City of Highland Park NATURAL RESOURCES COMMISSION

Wednesday, June 8, 2016
Highland Park City Hall
1707 St. Johns Avenue
Highland Park, Illinois
6:30 p.m.

To: Members of the Natural Resources Commission
From: Eric Olson, Planner II
Date: June 6, 2016
Re: 116 Deere Park Court– Steep Slope Variation Request

SUBJECT: 116 Deere Park Drive, Proposed Deck Expansion in the Steep Slope Zone

SITE PLAN
SCALE: 1" = 30'-0"

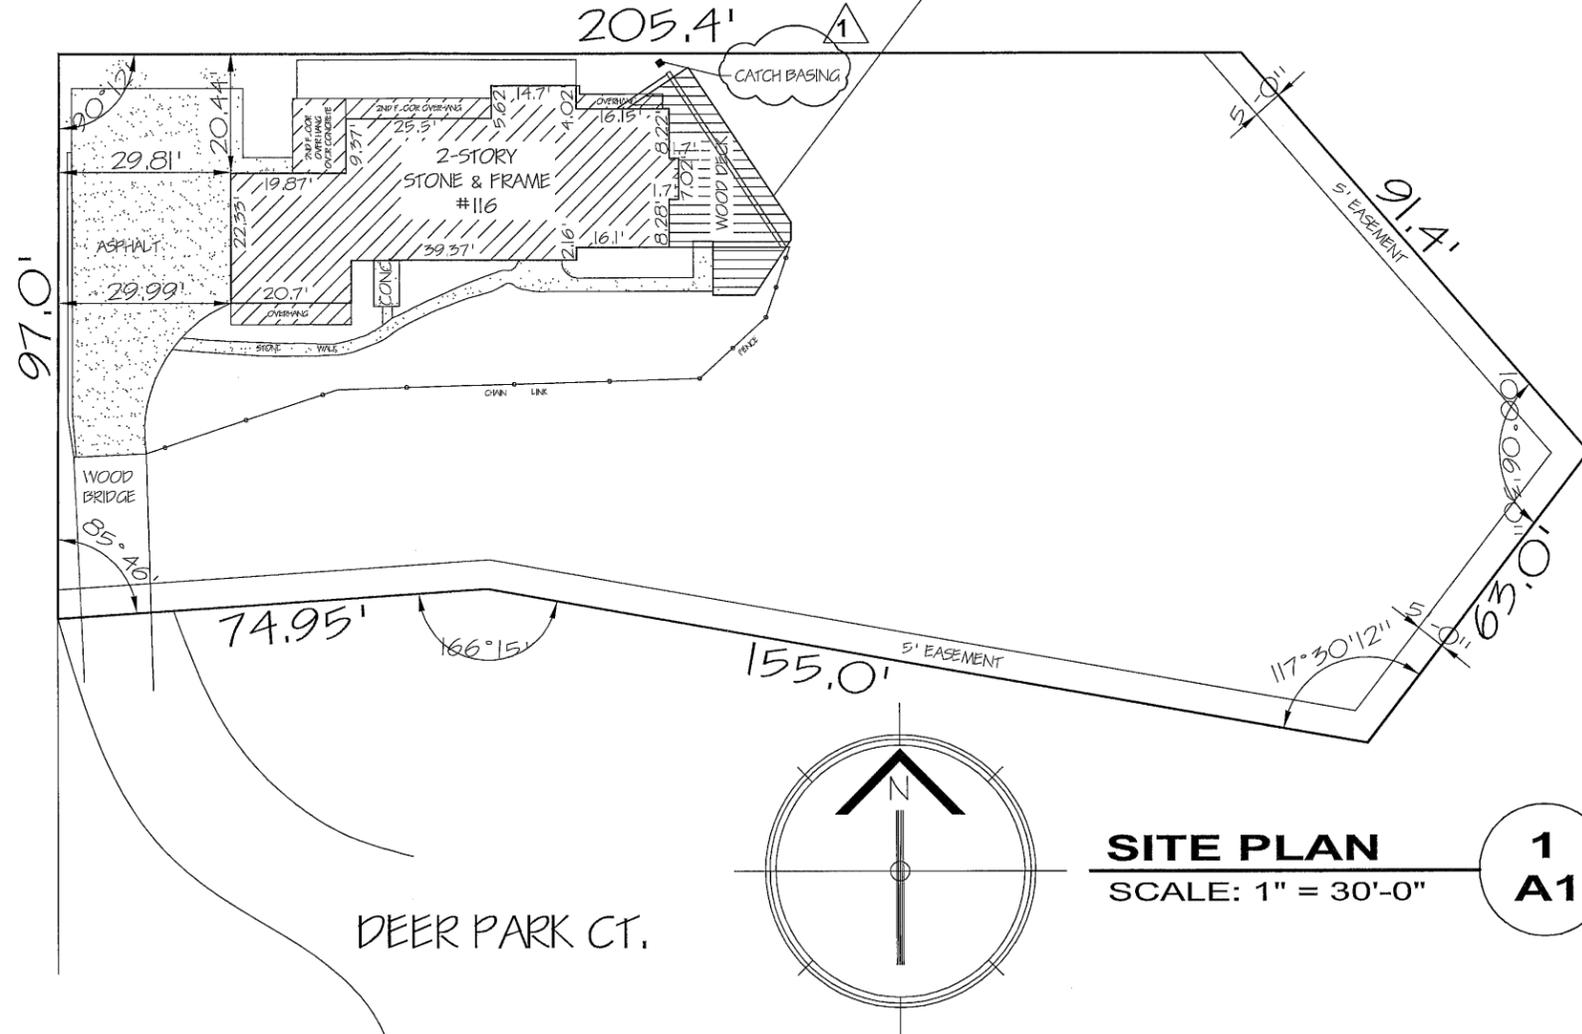
4. *The development minimizes disruption or alteration of natural drainage ways.*
 - Commissioner Pagoria noted that the area on the north side of the existing deck that has experienced erosion will have a catch basin installed.

The applicant has also provided further detail with regard to efforts to reduce erosion that had occurred at the north end of the existing deck, which includes raising the soil grade, contouring the soil, and protecting the soil with decking.

However, we have included additional detail on how we propose to deal with the erosion that is occurring at the far northwestern part of the deck, as indicated in new specifications provided in our amended plans:

- We would first increase the level of the subsoil along the far-end of the retaining wall with compacted gravel (at present, in this area, the subsoil is approximately 1 foot lower than the remaining deck subsoil level). This would provide additional

support for the back side of the end of the retaining wall and would lessen the rain run-off which now appears to be occurring on the hard compacted soil there.

- We would also cover this part of the raised subsoil with a small triangle of extended decking which would further protect against direct rainfall run-off.
- The soil underneath this area of decking would be contoured to allow the run-off that does not percolate into the retaining wall system to flow into a catchment basin as shown on the amended plans. Run-off from this catchment basin would be directed all the way down the slope by a separate 4-inch diameter conduit, thus avoiding overloading existing conduits. The architect has determined that the size of the basin is more than adequate to deal with any water run-off from this small triangular area.

CROSS SECTION
SCALE: 1/2" = 1'-0"

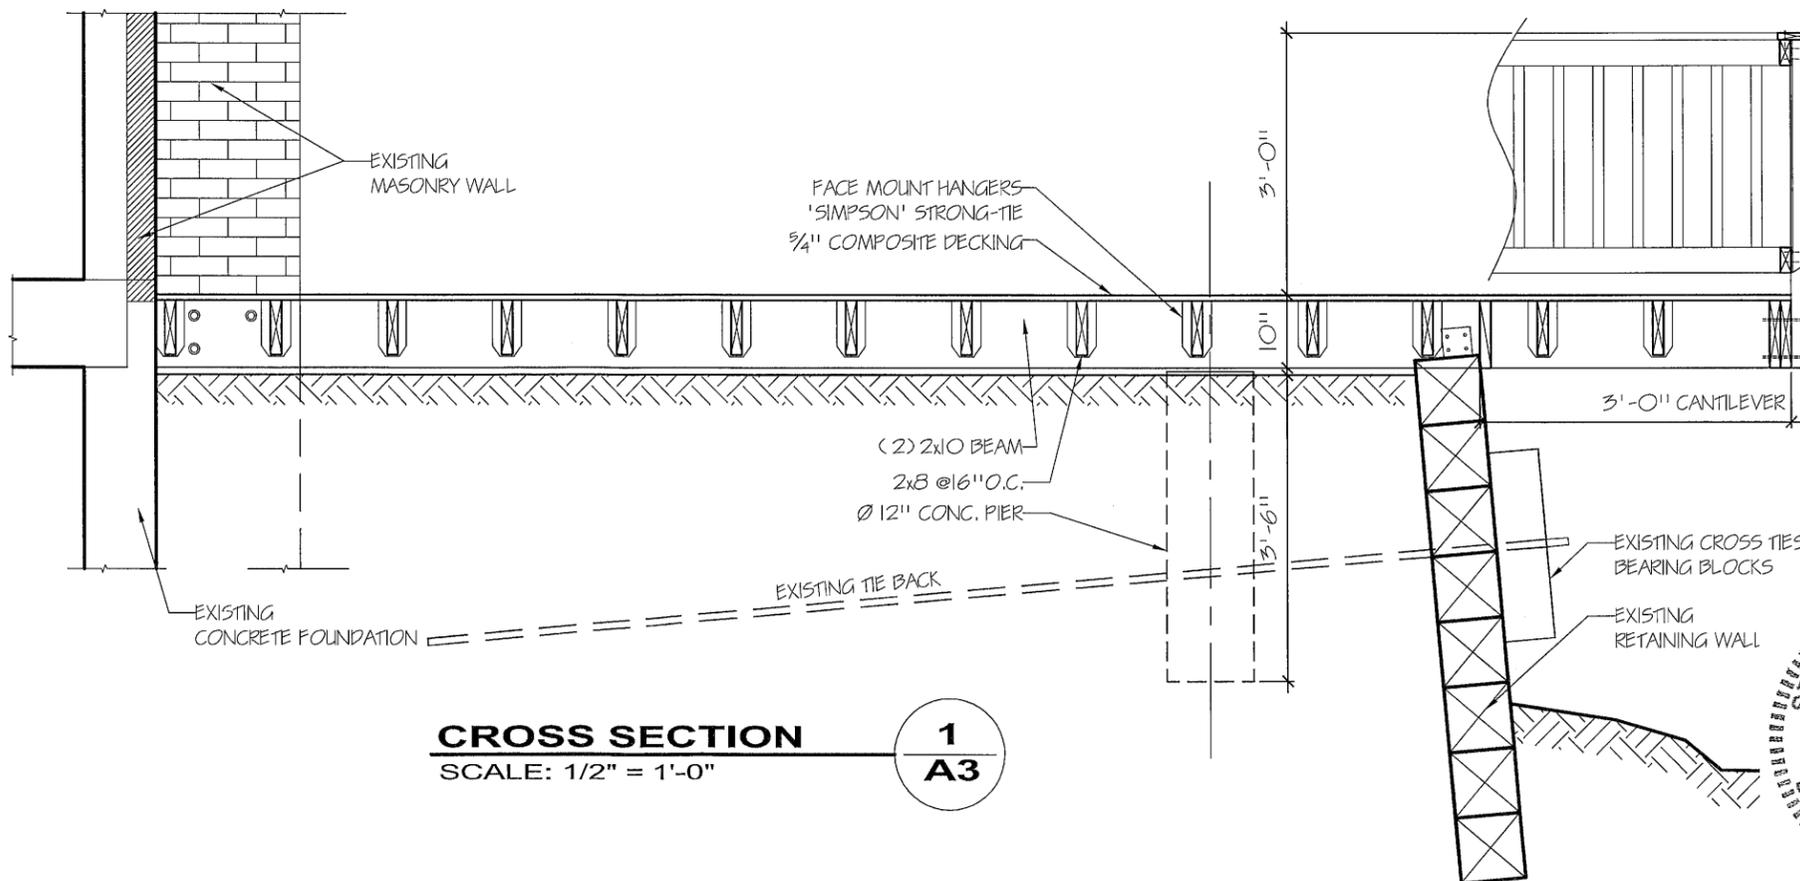
Vice Chair Wagenius asked about the extent of a impervious plastic membrane underneath the deck. Chairman Ross estimated that the membrane would be approximately 250 to 270 square feet.

Commissioner Coyle stated that it is a substantial change from the current condition of no impervious surface underneath the deck to the proposed plan that uses the plastic membrane underneath the deck. Councilwoman Stone then added that drainage will be impacted in the spring due to both water flow and ice melt.

The applicant has provided revised plans and an associated letter clarifying the use of a membrane and pea gravel underneath the deck as part of a drainage system. Originally, the plans were represented as included an impermeable plastic membrane which would direct water to a drain and catchment basin. The applicant now states that the ground

underneath the deck will be covered with a permeable fabric topped with pea gravel ballast to serve as a weed and plant barrier. Storm water will be able to pass through the deck planking, pea gravel, and fabric membrane, through the existing soil, and then out through the existing drainage pipes in the retaining wall.

The actual specifications call for covering the deck’s sub-surface with a permeable fabric topped with pea gravel ballast merely to serve as a weed and plant barrier. Water would run off the deck through spacing allowed between the deck planking and would percolate through the existing compacted gravel soil and out the originally designed drainage conduits in the wall. This method has worked quite well since the retaining wall was installed in 1980. There is no erosion at any place along the base of the wall as noted in photographs taken during the site visit just prior to the May 11th meeting.
